To: Cumberland Planning Board
From: Carla Nixon, Town Planner
Date: May 14, 2019
Subject: Amendment to Major Site Plan - Friends School - Route 1

**RE: Response to Town Comments
Major Site Plan Amendment
Friends School, 11 US Route One
Cumberland, Maine**

Existing Lighting

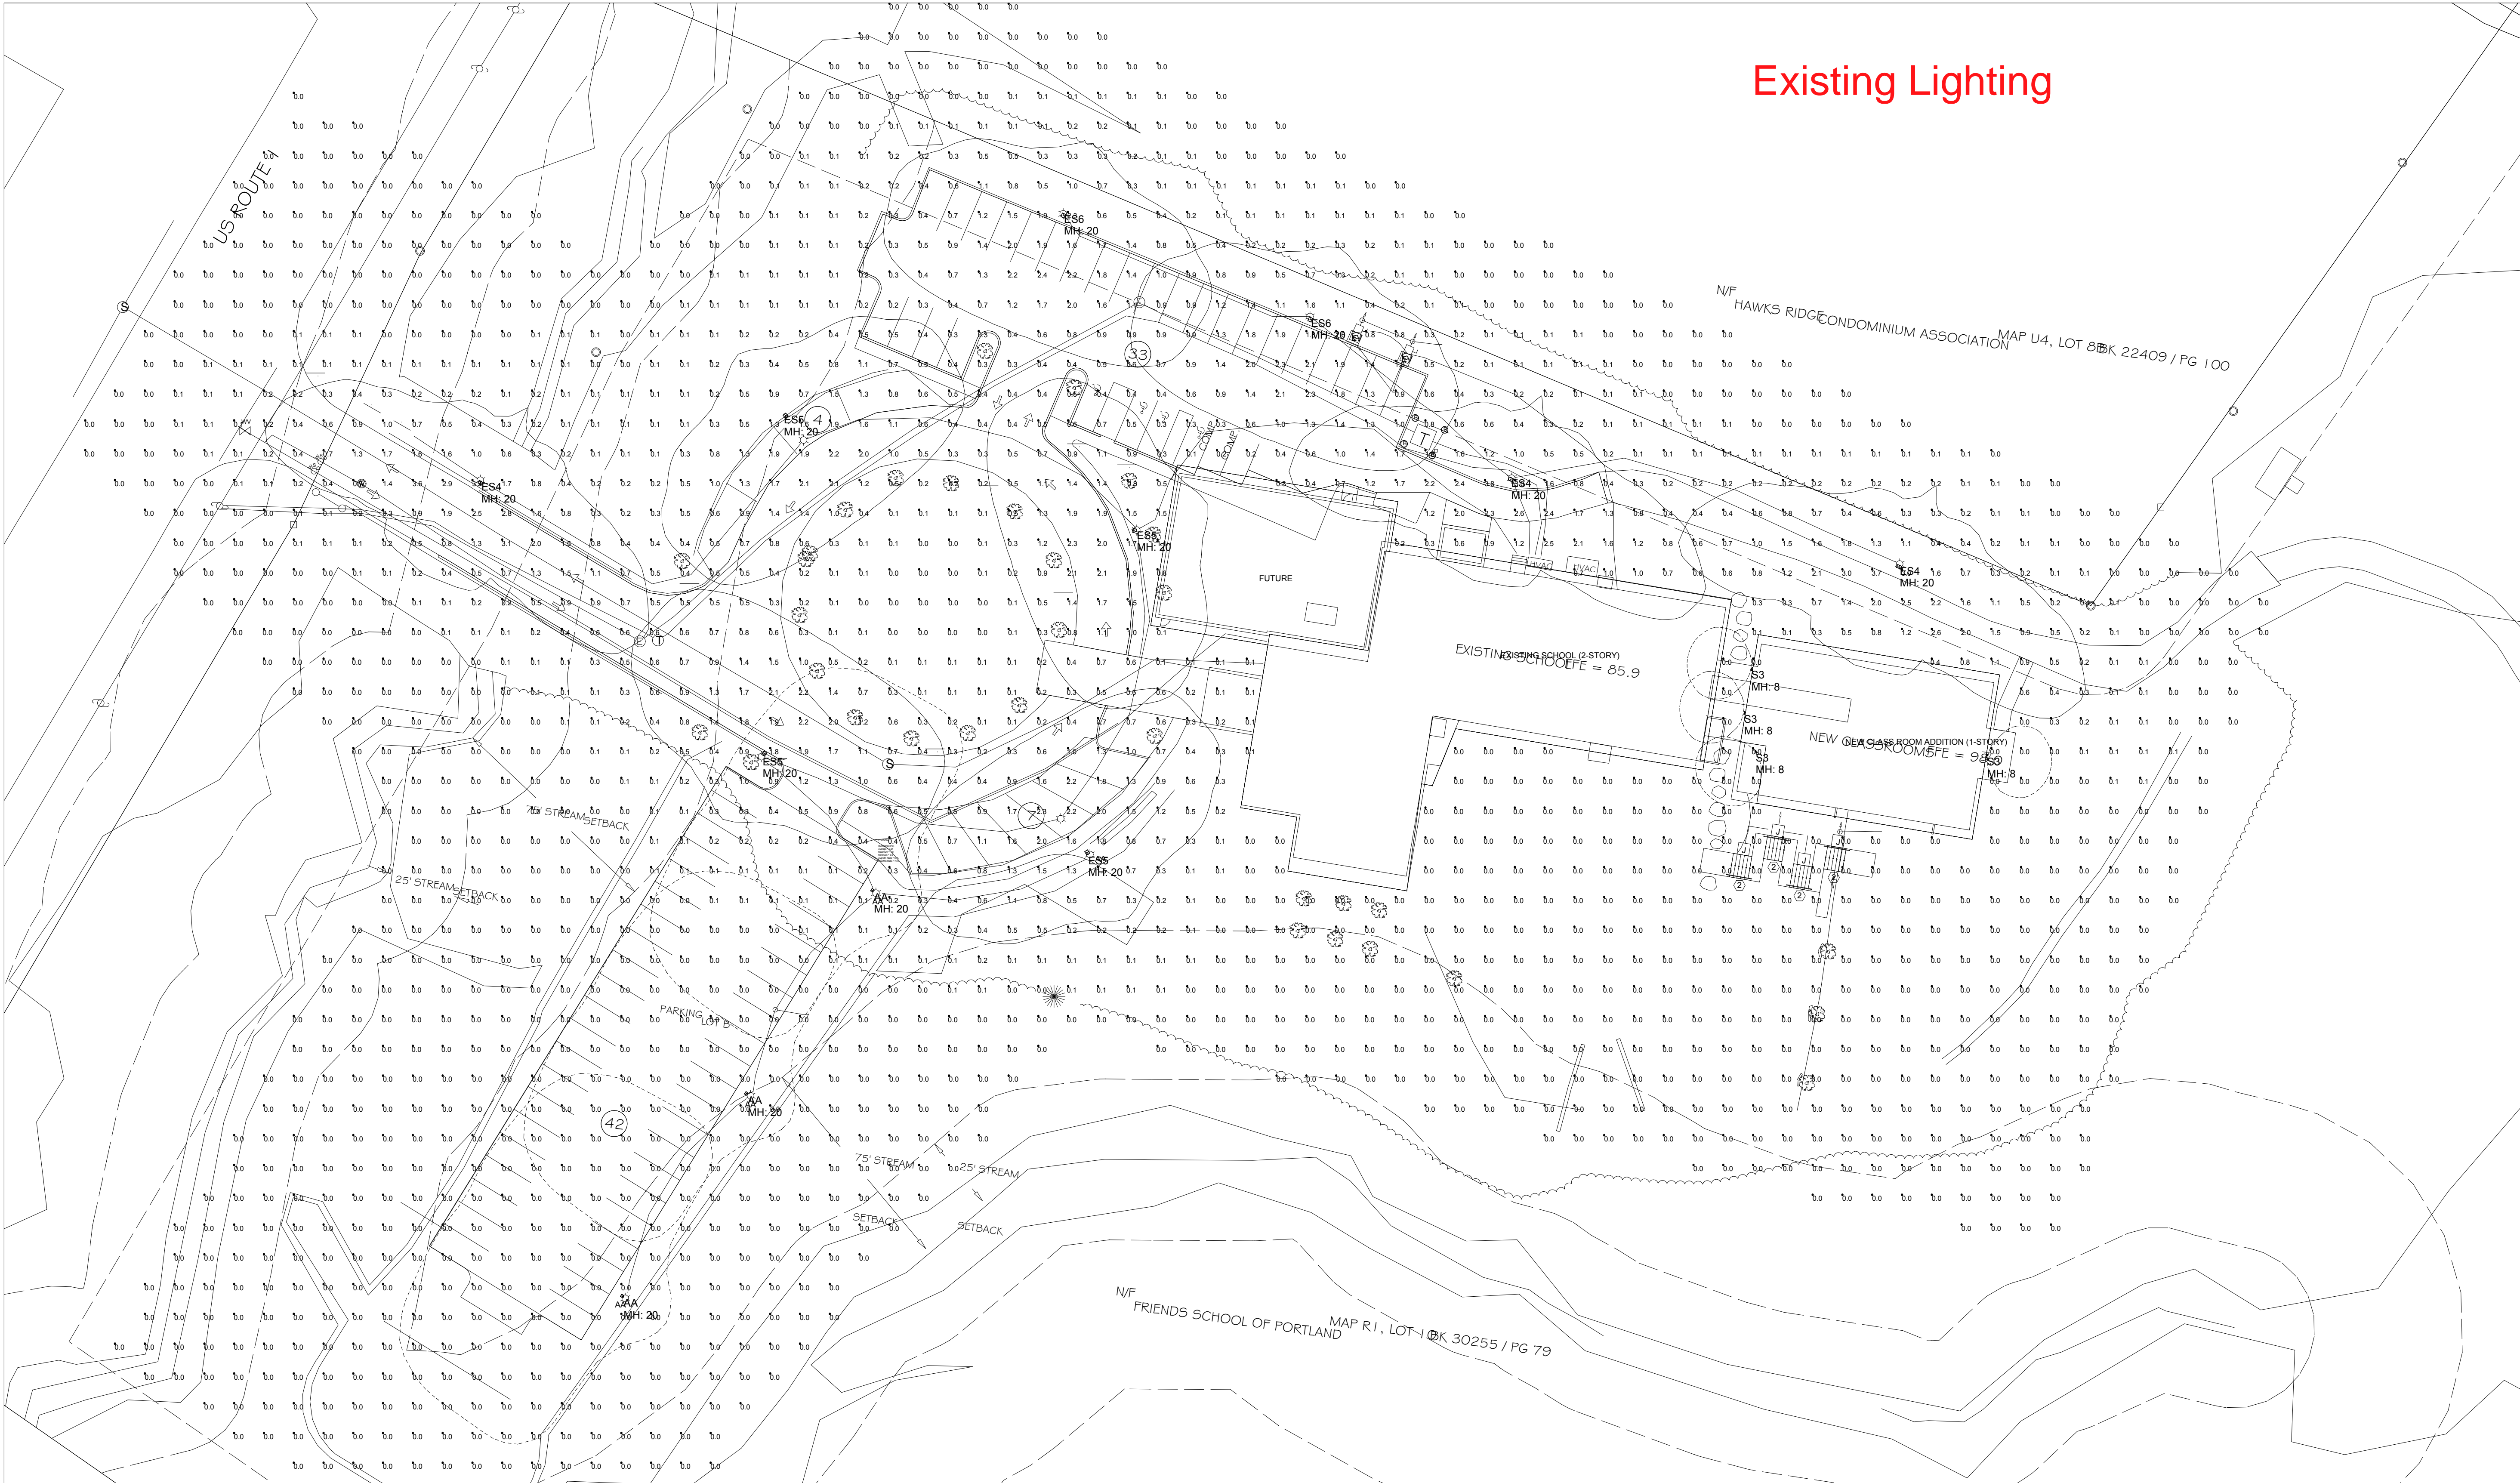
8. Please provide a revised lighting plan that clearly shows the existing and proposed exterior building and site lighting. Also address the slight trespass of light on the northerly boundary line with Hawks Ridge.

The encroachment of lighting onto the Hawks Ridge property is an existing condition from the original construction. Two photometric plans are enclosed. An existing conditions lighting plan shows the existing lighting levels. A proposed lighting plan shows the existing and proposed lighting and shows that the proposed lighting does not impact the lighting offsite onto the Hawks Ridge property. To our knowledge, there have been no complaints from Hawks Ridge in regards to lighting.

LAYOUT & UTILITIES PLAN
C2.1

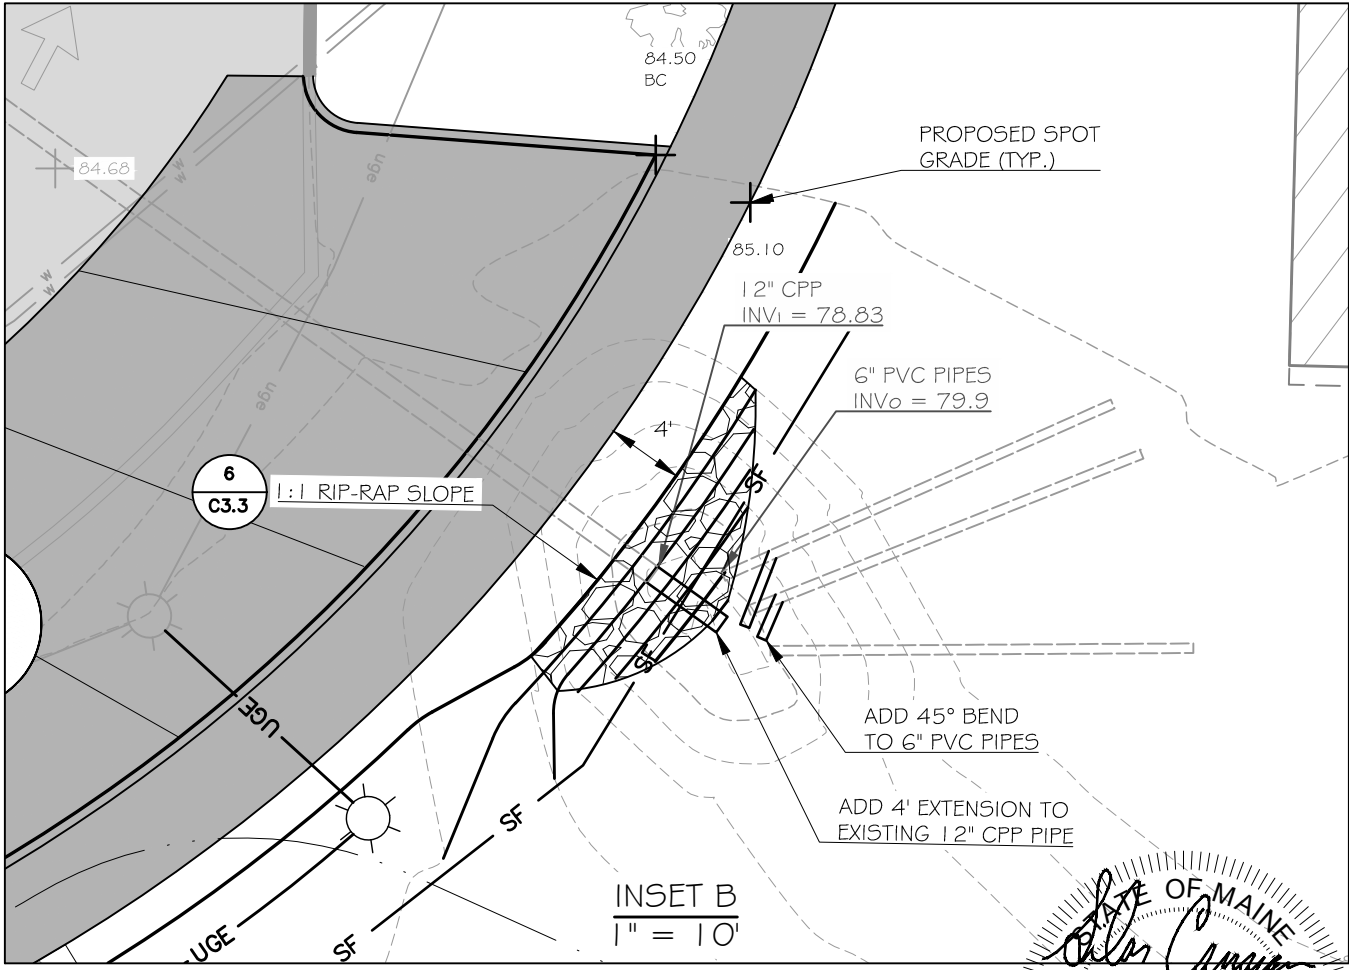
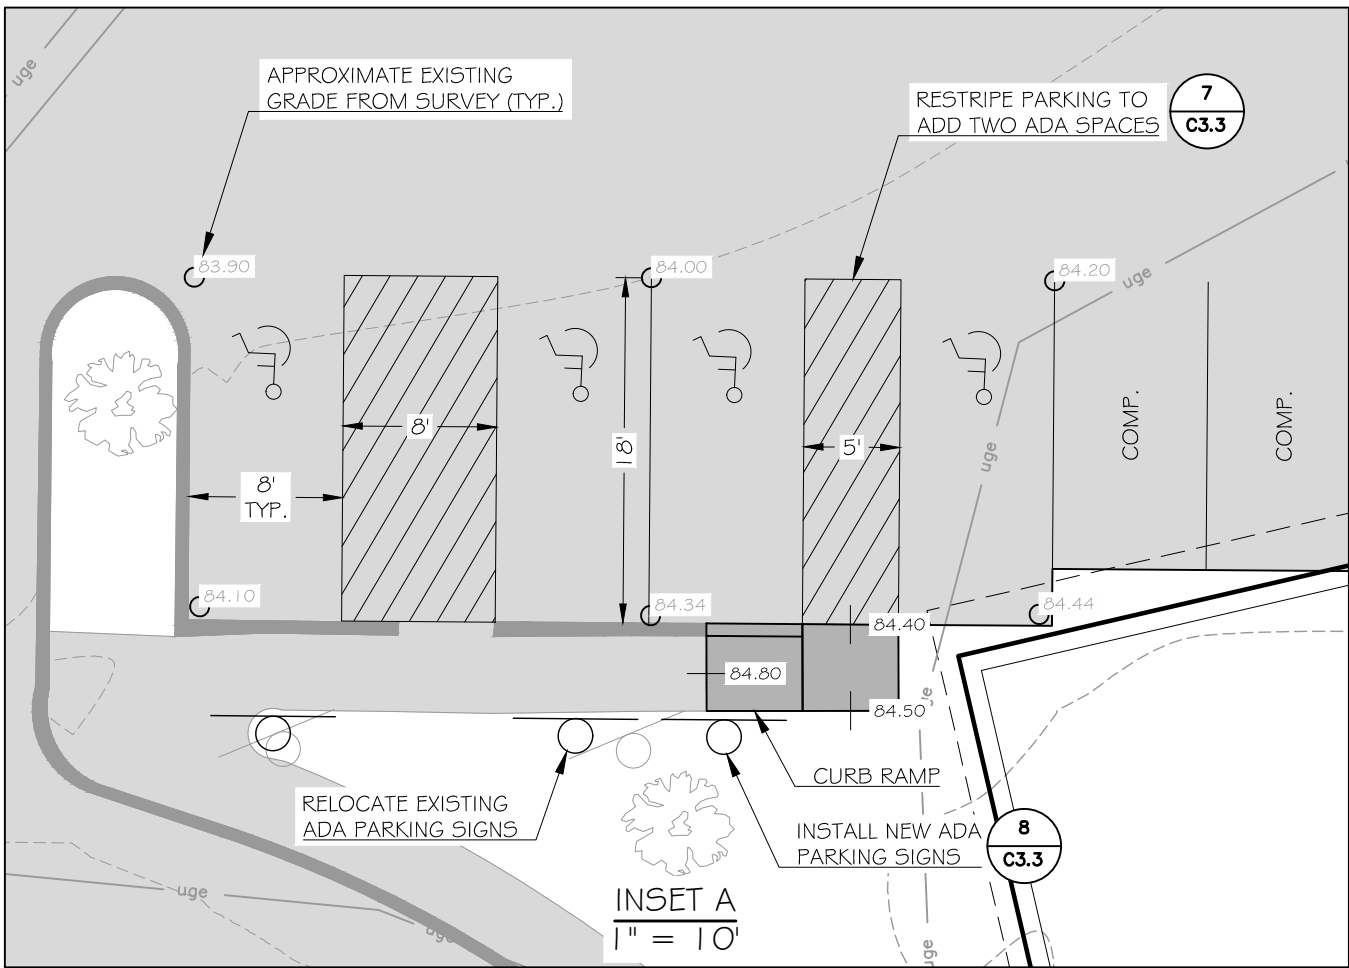
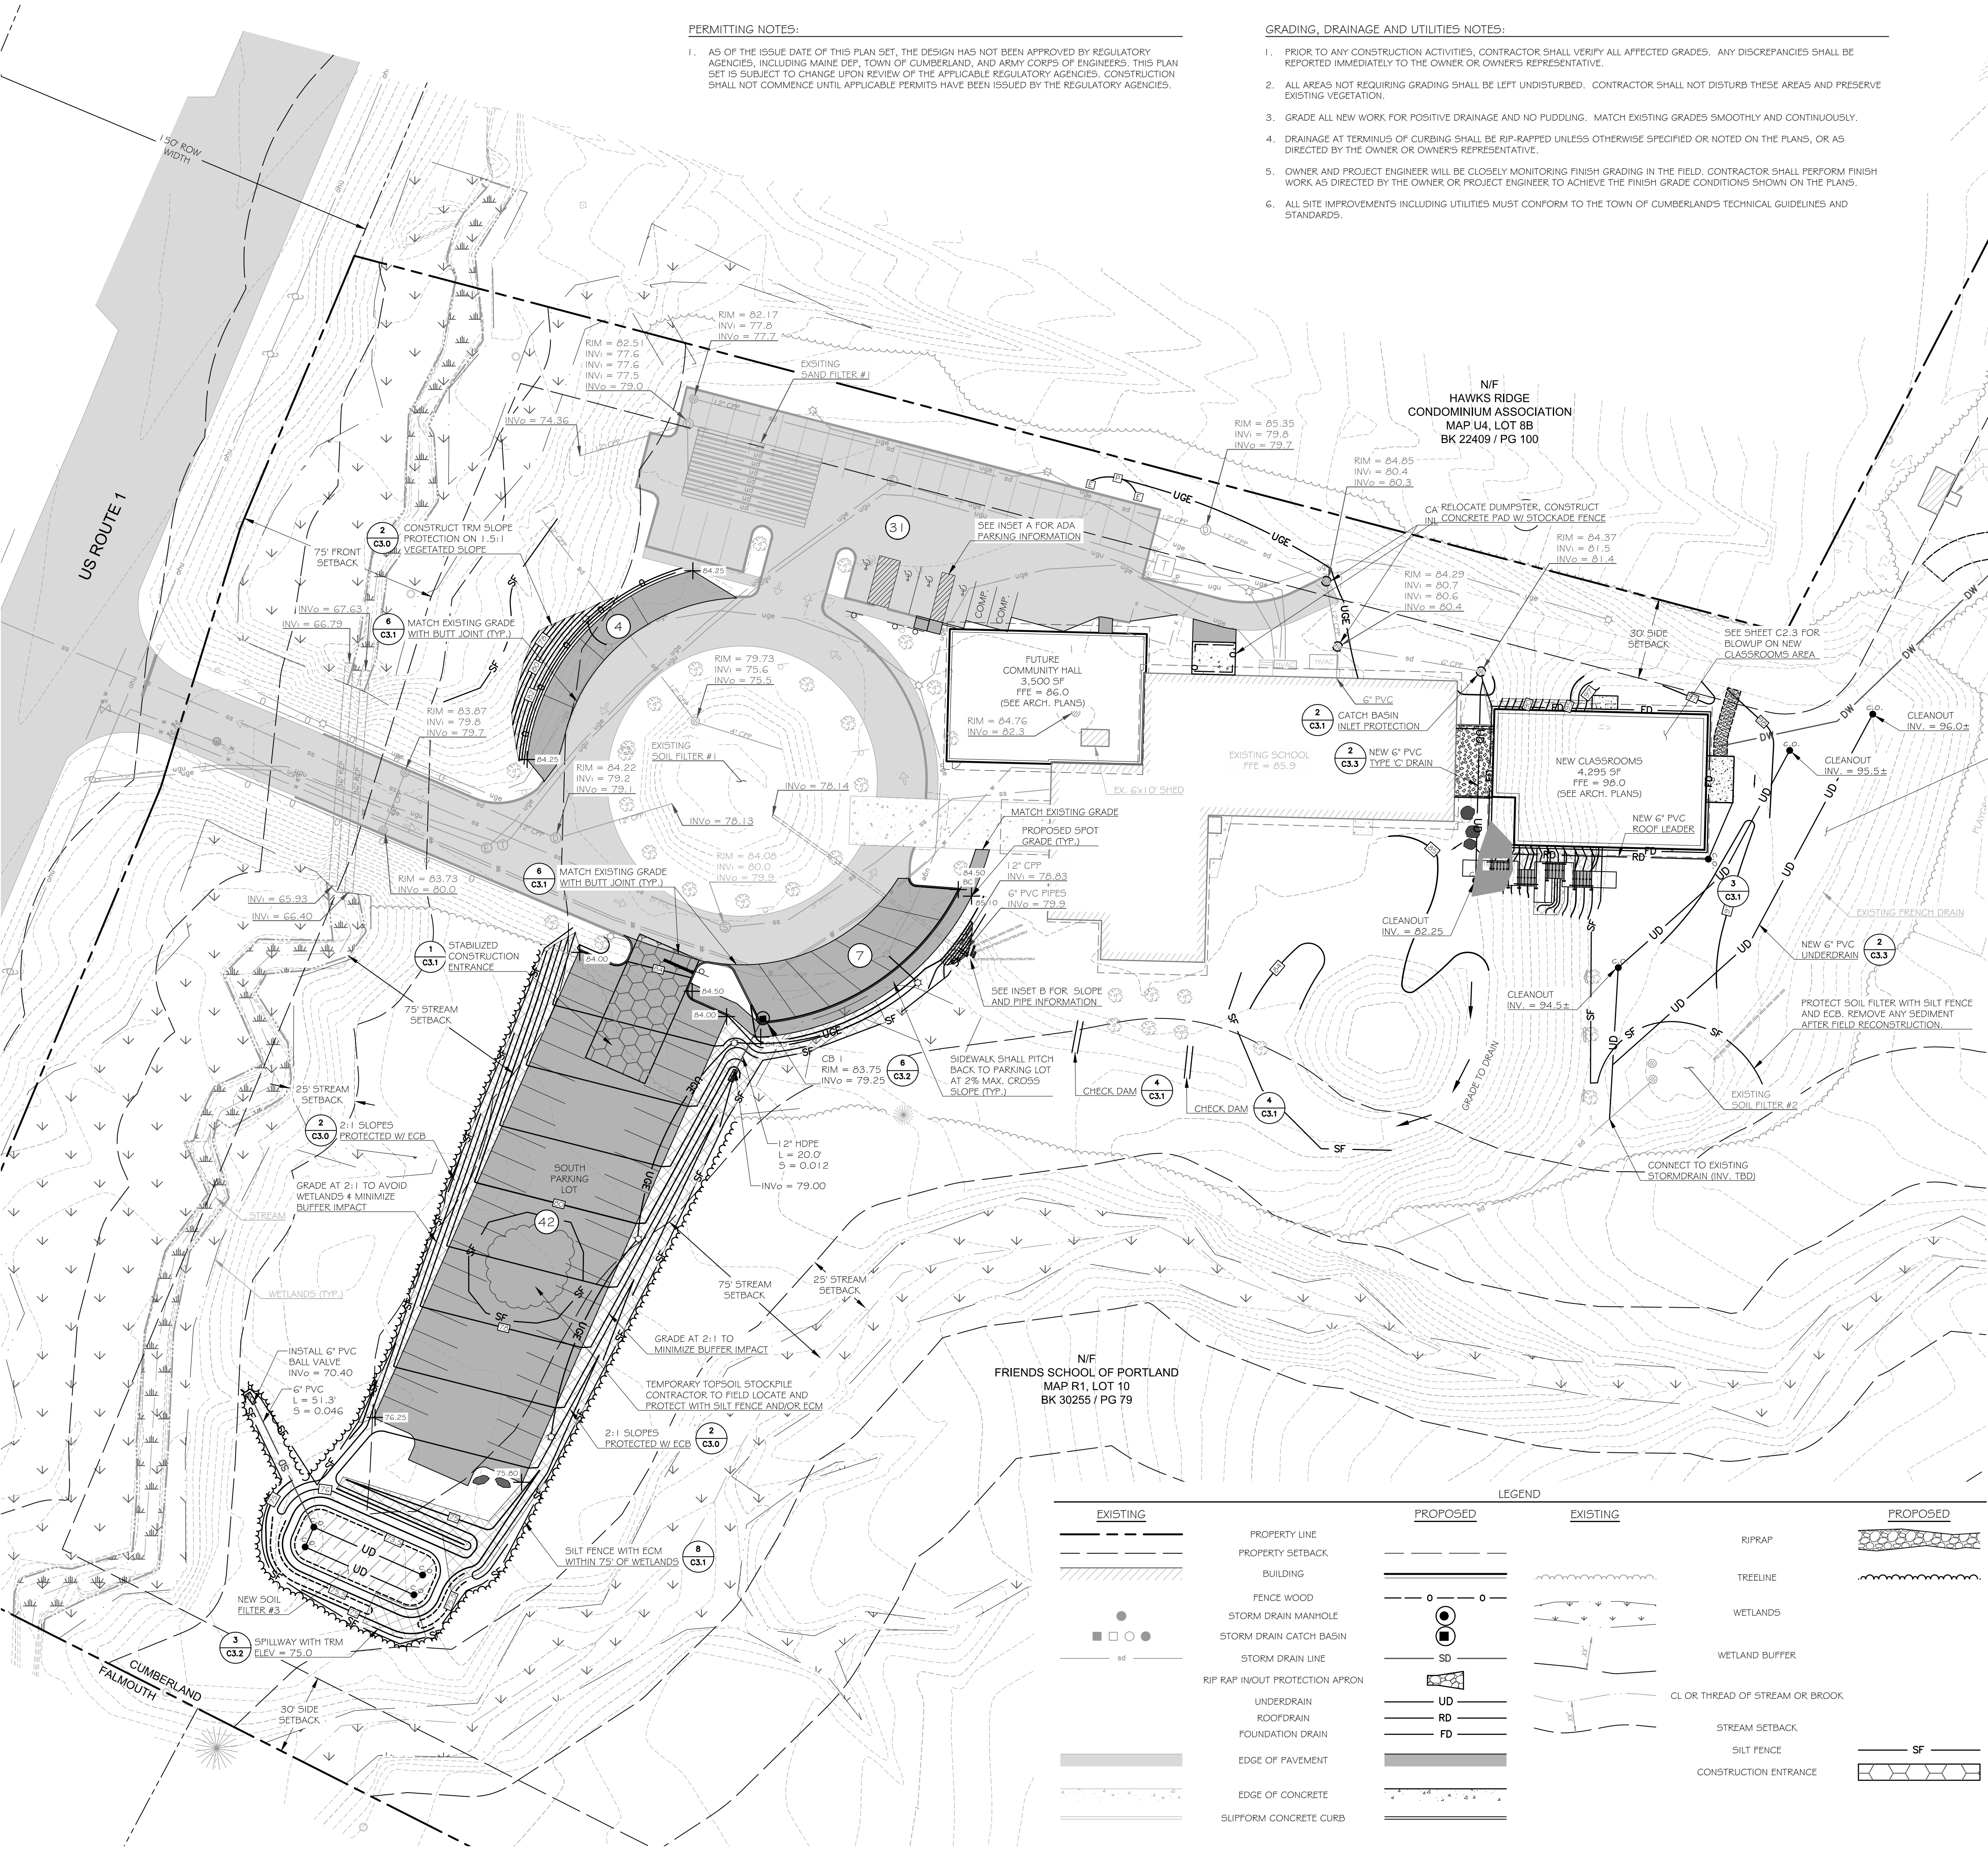
4. The invert of the 4" underdrain shown on sheet C-2.1 is listed at 72.75. This would place the pipe 6" below the bottom of the soil filter. Please revise the invert to match the detail for Underdrained Soil Filter #3.
